Proposed Modifications to IEEE P802.3az/D0.9 Clause 40

Adam Healey, Niall Fitzgerald, Jacobo Riesco, Brian Murray LSI Corporation

IEEE P802.3az Task Force Meeting Seoul, KR September 2008

chou_01_0908: Case 2

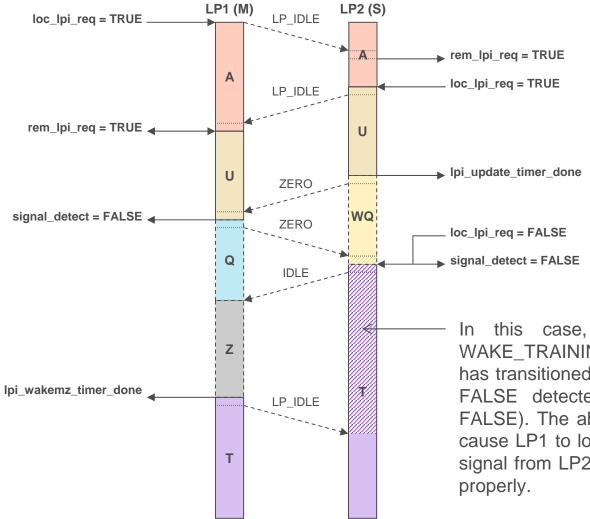
In this case, LP2 falls through to the WAKE_TRAINING state before it realizes LP1 has transitioned to QUIET (e.g. signal_detect = FALSE detected slightly after loc_lpi_req = FALSE). The absence of signal from LP1 may cause LP1 to lose timing while the presence of signal from LP2 may prevent LP1 from training properly.

Corrective actions

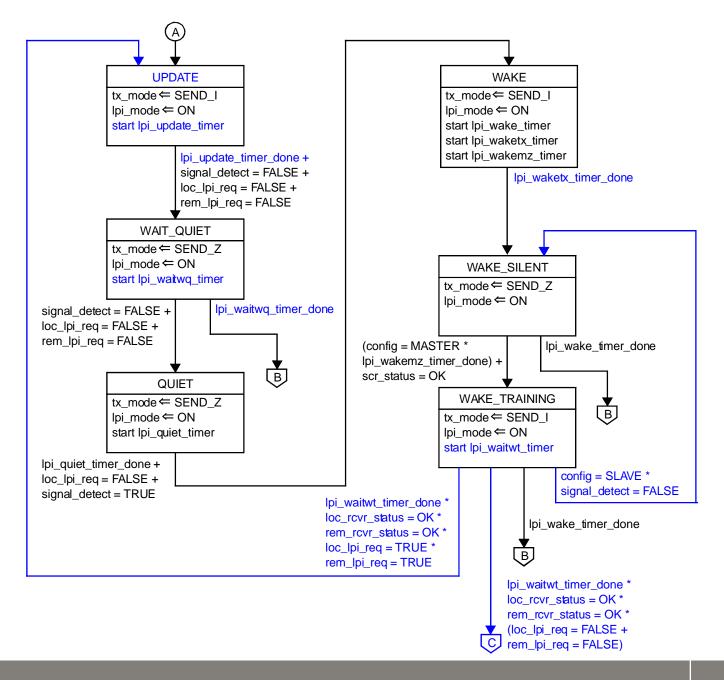
- Refer to the proposed state diagram in the next slide...
- Note changes recommended in grimwood_01_0908.pdf included for completeness

Supporting edits

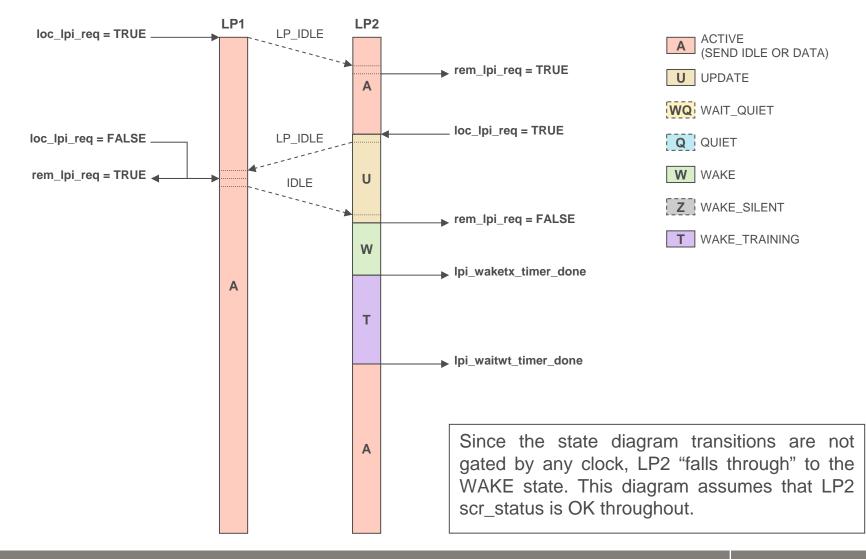
- 40.4.2.4: Upon activation of the low power mode, the PHY Control asserts tx_mode = SEND_I for period of time defined by http://pi_sleep_timerlpi_update_timer which allows the remote PHY to prepare for the transition to the WAIT_QUIET state. When http://pi_sleep_timerlpi_update_timer expires, PHY Control asserts tx_mode = SEND_Z and transmission ceases.
- 40.4.5.2: Delete lpi_sleep_timer
- **40.4.5.2**: Replace lpi_wait_timer with lpi_waitwt_timer

This timer defines the minimum time the PHY must remain in the WAKE_TRAINING state.

Values: The condition lpi_waitwt_timer_done becomes true upon timer expiration.

Duration: This timer shall have a period between 1.8 µs and 2.0 µs.

Supporting edits (continued)

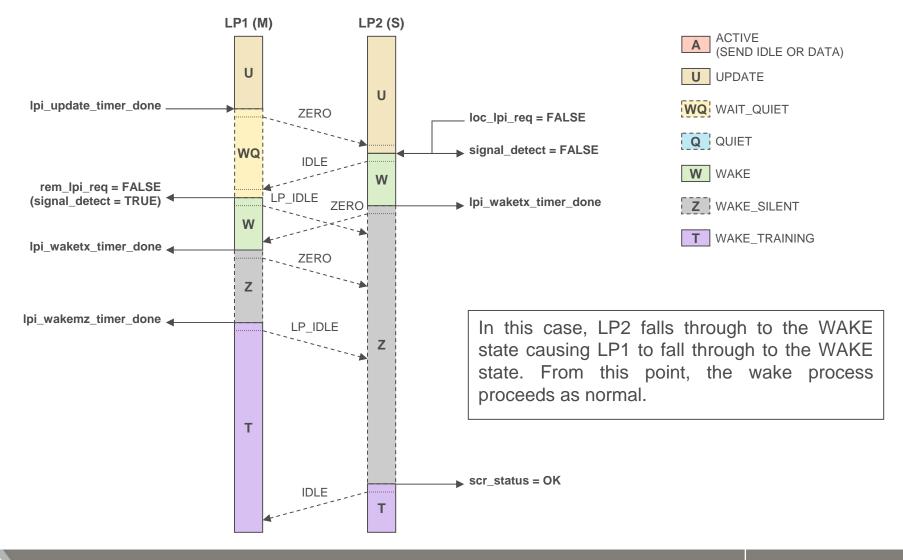
• 40.4.5.2: Add lpi_waitwq_timer

This timer defines the maximum time the PHY will dwell in the WAIT_QUIET state before forcing the link to restart.

Values: The condition lpi_waitwq_timer_done becomes true upon timer expiration.

Duration: This timer shall have a period between 4.5 μ s and 5.0 μ s.
